CITY OF CORCORAN
Corcoran Planning Commission Agenda
September 3, 2020 - 7:00 pm

RE: Nelson International Conditional Use Permit, Site Plan and Variance for the property at 10409 County Road 101 (PID 01-119-23-41-0001) (city file no. 20-022)

Subject: Nelson International – Plan Review Comments

SITE PLAN
C2-1

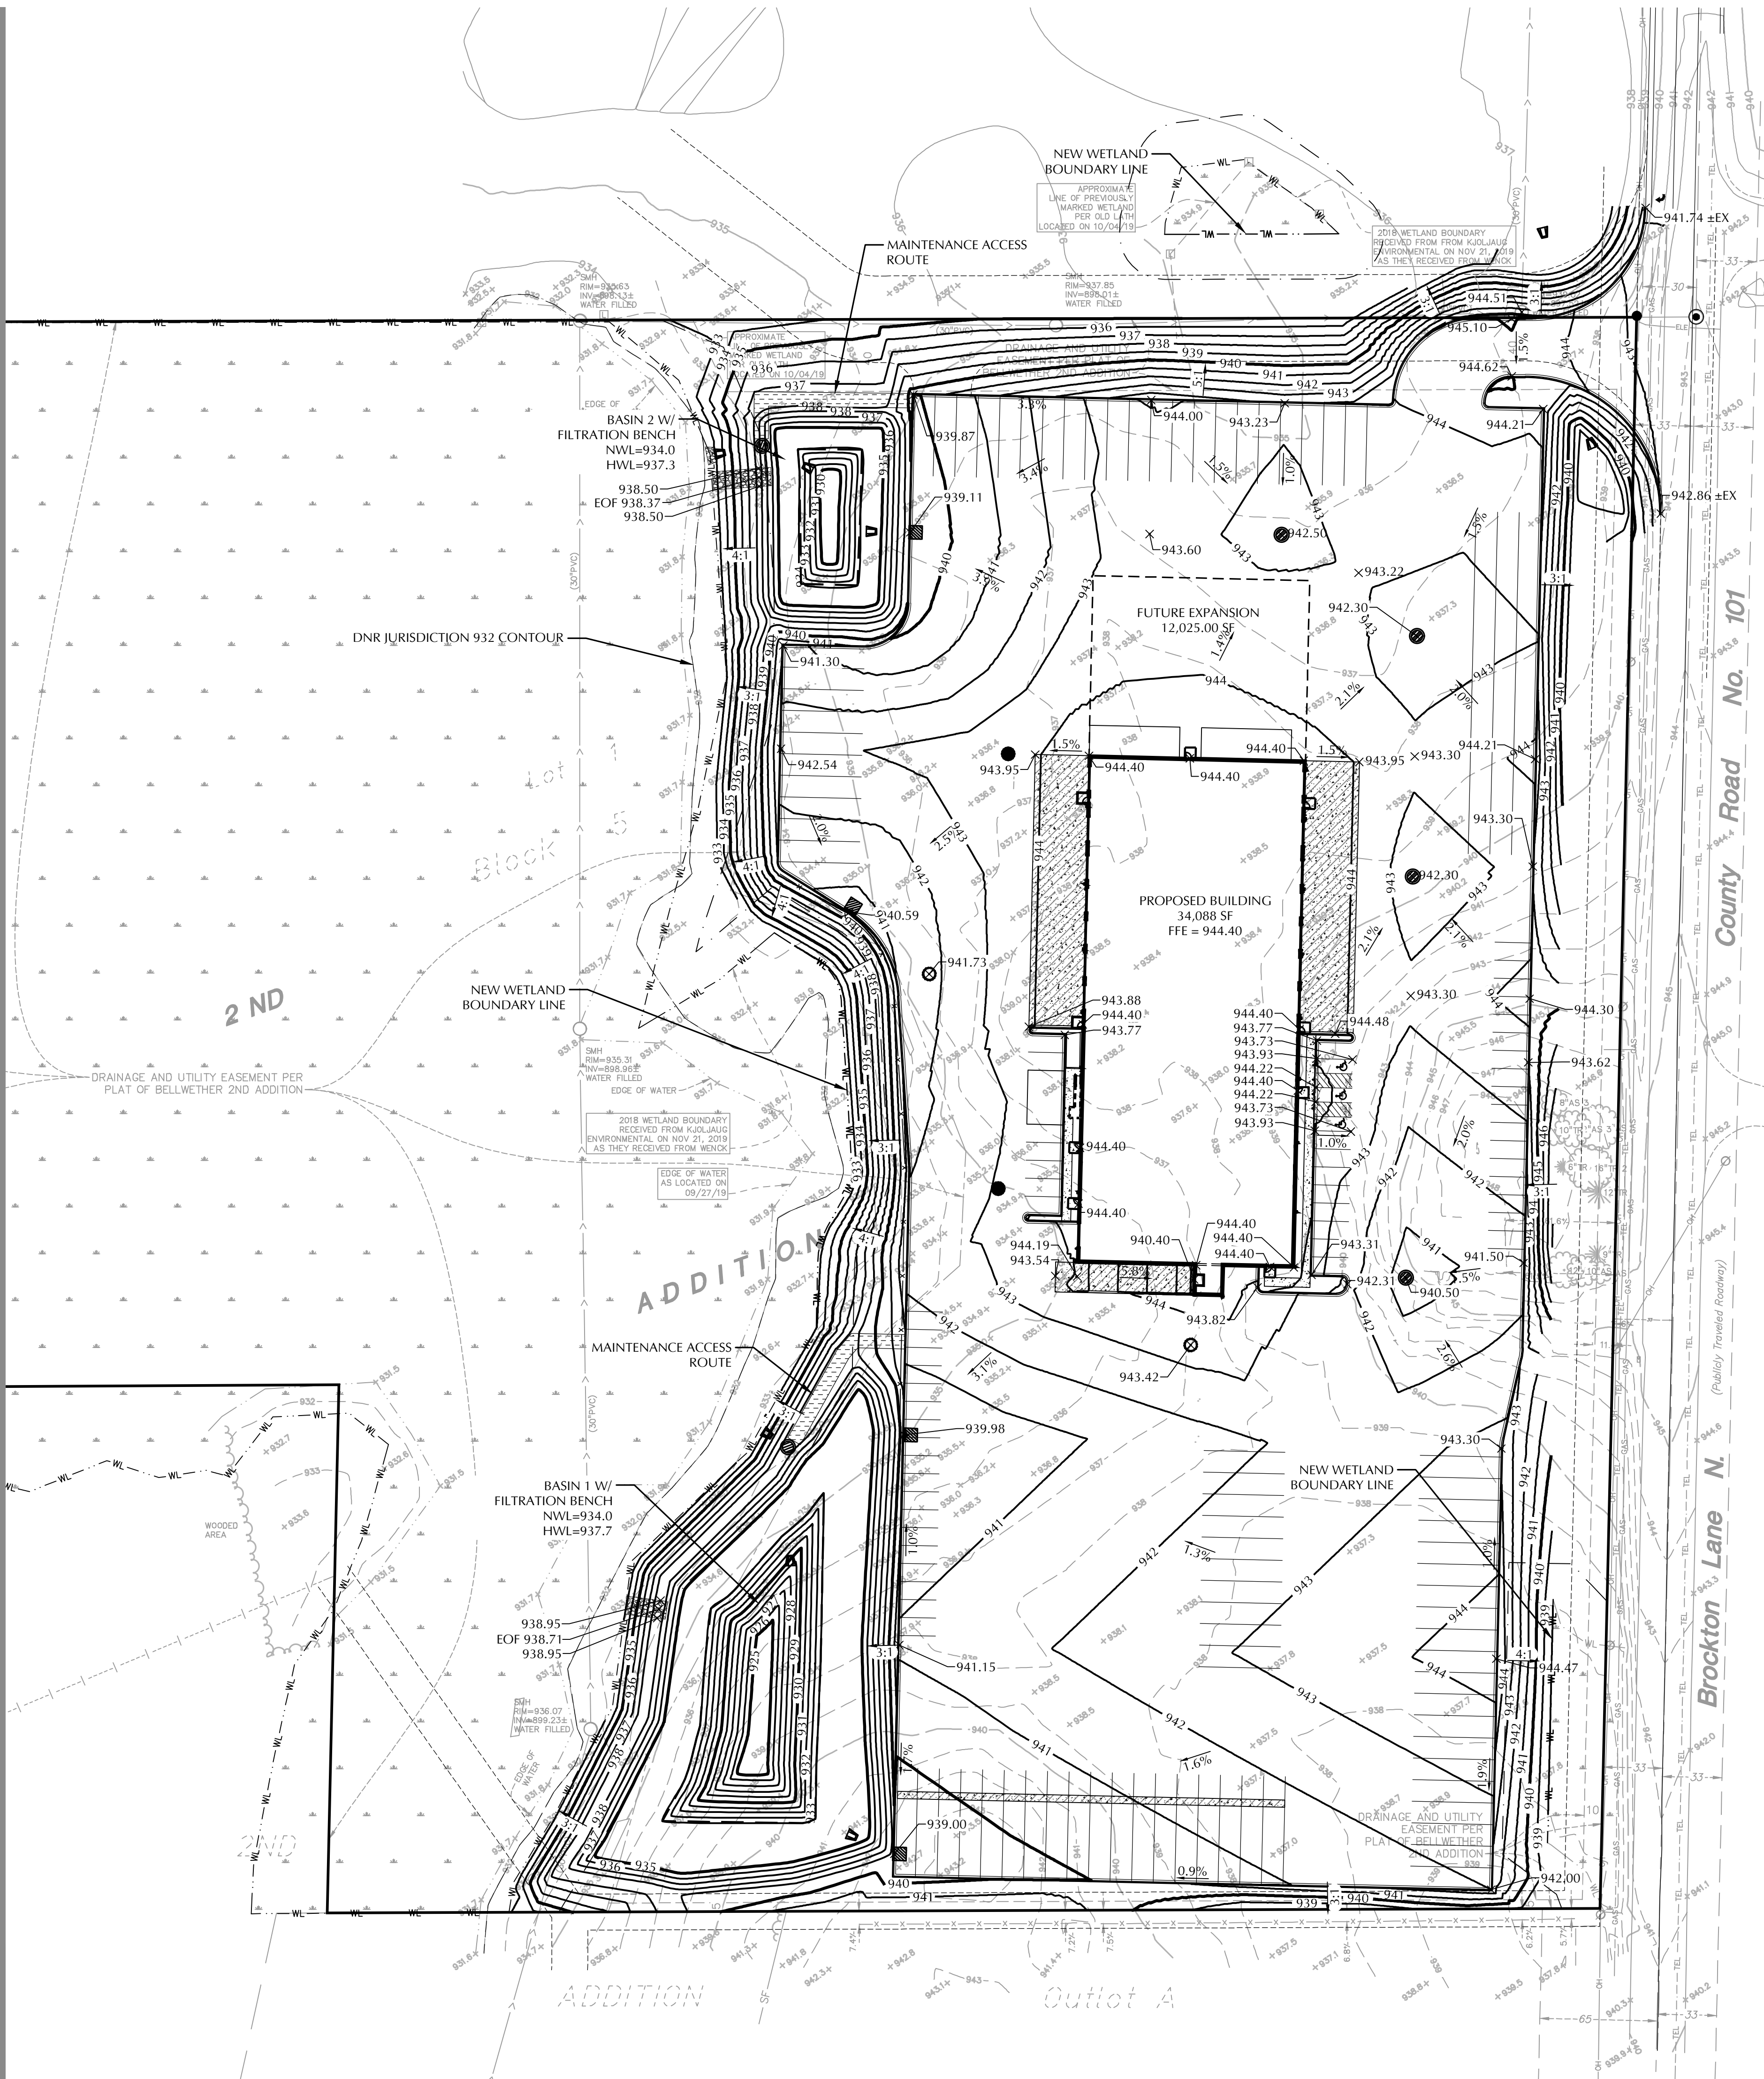
A trash enclosure has been added to the plans. The trash enclosure is screened with fencing and complies with the ordinance standards. The trash area is on the rear of the building and has parking on both the north and south side of the enclosure. Staff suggests that the applicant consider shifting the trash enclosure to the north to eliminate the parking stalls north of the enclosure. The two stalls could be moved to the other side of the enclosure to cluster the parking together.

The applicant is reducing the parking setback via the flexibility allowed by Section 1060.070 Subd. 2(L) of the Zoning Ordinance. This requires the applicant to provide landscaping beyond the minimum requirements or preserve significant landscaping in the area. The required setback may be reduced to the required front setback from other streets in that district if the applicant provides a minimum of one overstory deciduous tree, one overstory coniferous tree, two ornamental trees and 10 understory shrubs per 100 feet of the length of the property line where the flexibility is requested or preserves the equivalent number of existing trees and shrubs. These materials must be provided in addition to the minimum landscape requirements. This would allow the applicant a reduced parking setback of 50 ft. The applicant is showing a setback of 50.67 ft.

The plan shows a total of 95 parking stalls for customer, company, service and overflow parking where a total of 67 parking stalls are required: 36 for retail, 13 for warehousing and 18 for auto service.

Additionally, the plans show 20 stalls for vehicle sales and 18 stalls for trailer parking in the southern portion of the site. There is also a service drop-off in the northeast portion of the site for three trucks/trailers awaiting service. 7 of the 18 stalls for trailer parking will be used for snow storage during the winter. Staff supports this method of snow storage with the condition that trailer storage will not be done elsewhere and will be reduced during the winter months.

6. The freestanding sign shall be relocated outside of the parking area or the parking stall be converted to a landscape island.
7. A revised lighting plan is required to be submitted for review and approval by the City.

LANDSCAPE PLAN
L1-1

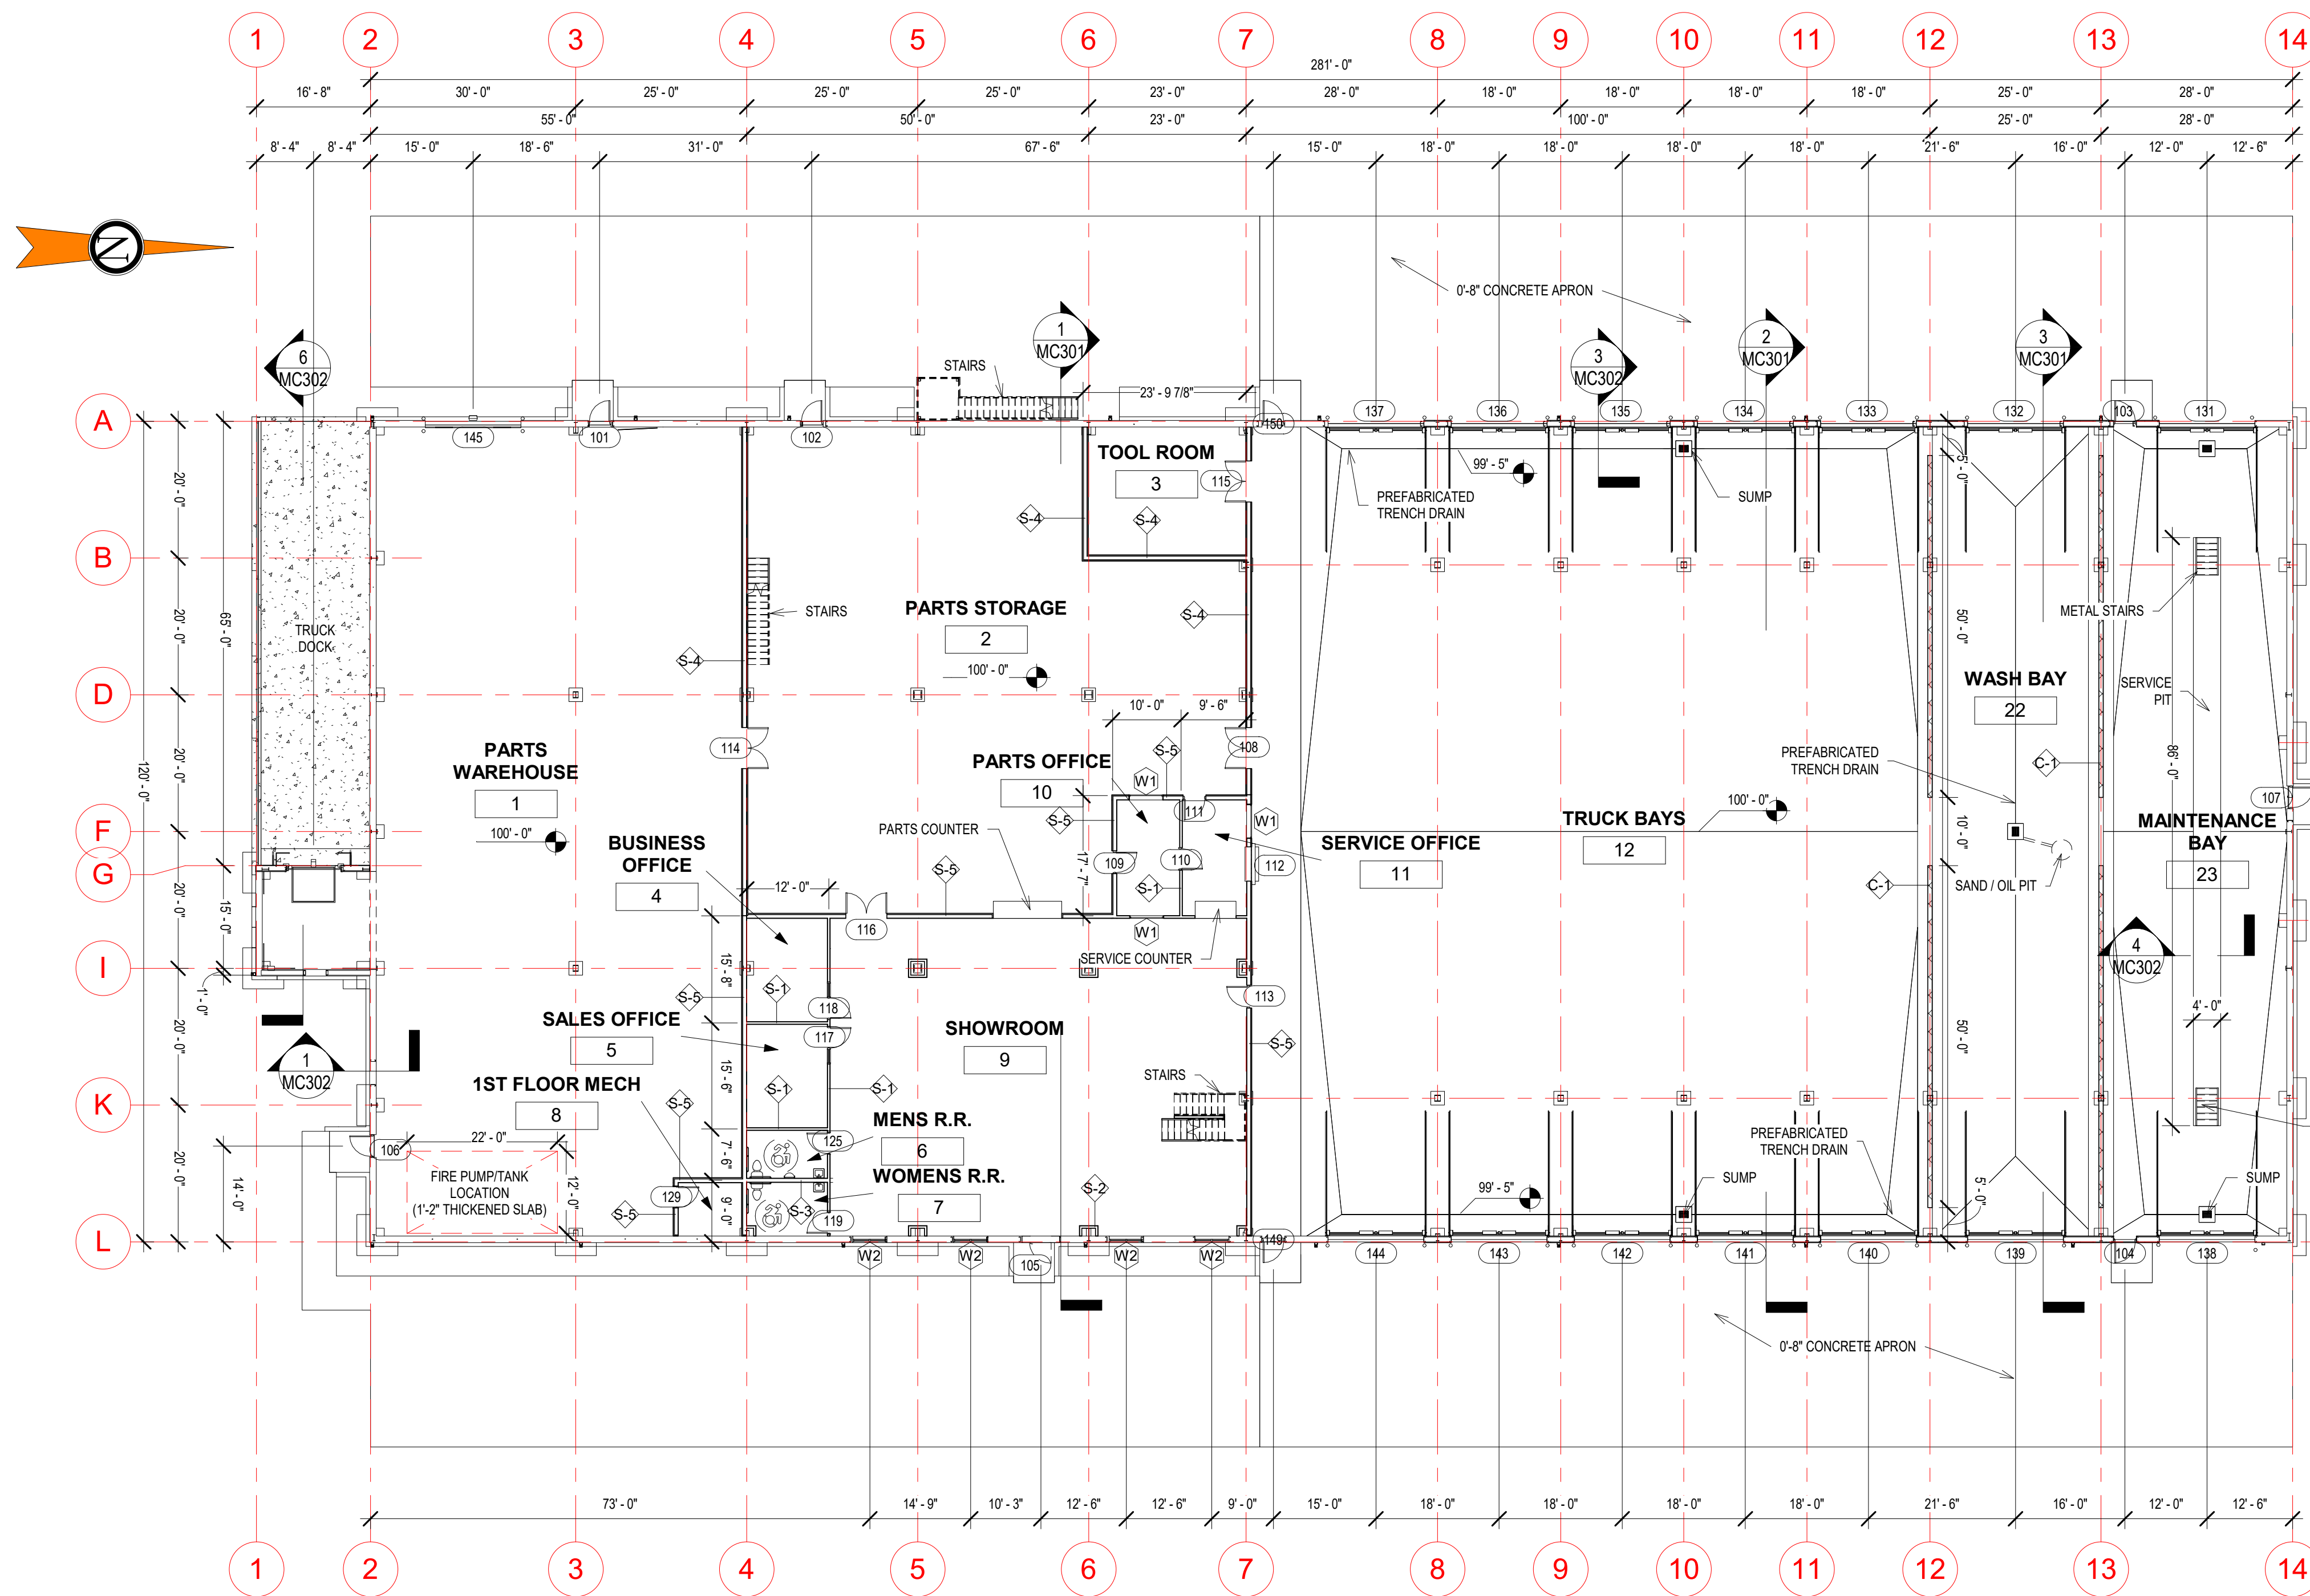
The applicant has shown additional overstory, ornamental and understory trees to allow reduced setback flexibility on CR 101, but did not provide enough information to confirm that the requirements have been met. A total of 70 overstory deciduous trees, 20 overstory coniferous trees, 18 ornamental trees, and 260 understory shrubs are proposed. The applicant has proposed more coniferous trees and understory shrubs than are required to provide additional screening along the parking lot to block headlights and along the southwest corner to increase screening from the residential uses to the south and west. Staff believes the placement of the plantings along the southwest corner and the west side of the property will provide adequate screening.

Staff continues to be concerned that the landscaping along County Road 101 may conflict with the future planned water main. Staff has included a condition that the applicant continue to work with staff to coordinate the landscaping to ensure no conflict exists.

The applicant's proposed layout shows both options. If water is secured from Maple Grove, the landscaping plan or utility plan will need to be revised to avoid conflicts between the proposed trees and the proposed watermain. This issue must be resolved prior to execution of the development agreement.

- c. The applicant shall submit detail sheets for each exterior lighting fixture. Base details shall be included with the detail sheet.
8. The applicant shall continue to work with city staff to coordinate landscaping to ensure no future conflict with the planned watermain along County Road 101.
